Program Bulletin

CUSTOMER SATISFACTION PROGRAM

SUBJECT: Front and Rear Door Handles May Stick or Bind

MODELS: 2013 Buick LaCrosse, Regal, Verano
2013 Cadillac SRX
2013 Chevrolet Cruze, Malibu
Equipped with Keyless Entry Feature (ATH)

3415788

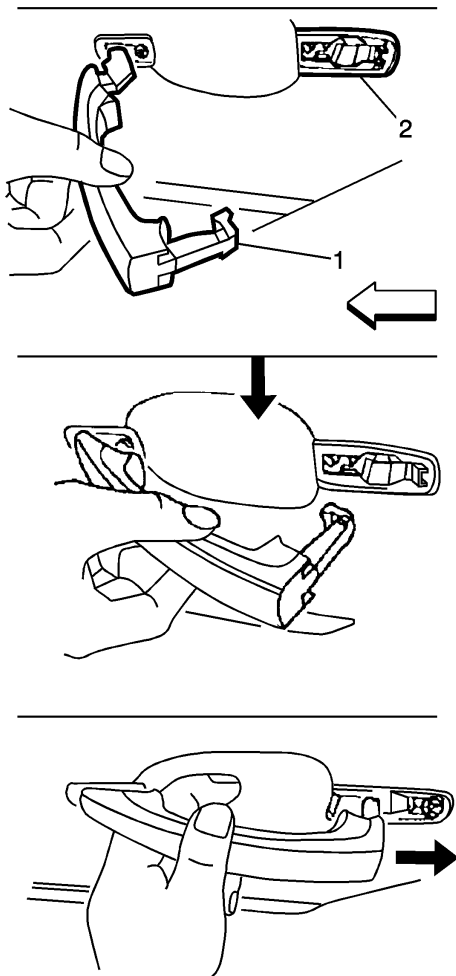
7. Measure the leg of the door handle as shown. Ensure the thickness is between 5.7 mm (0.224 in) and 5.9 mm (0.232 in).

- If the thickness is between 5.7 mm (0.224 in) and 5.9 mm (0.232 in), the door handle leg does NOT require modification. Proceed to step 8.

- If the thickness is greater than 5.9 mm (0.232 in), use a flat file or fine grade sand paper to remove material from the area identified by the arrows. Remove an equal amount from both sides of the door handle leg. The final thickness should be 5.7 mm (0.224 in). Proceed to step 8 after removing the appropriate amount of material from the door handle.

Note: Removing too much material may create a rattle condition. The final thickness should be 5.7 mm (0.224 in).
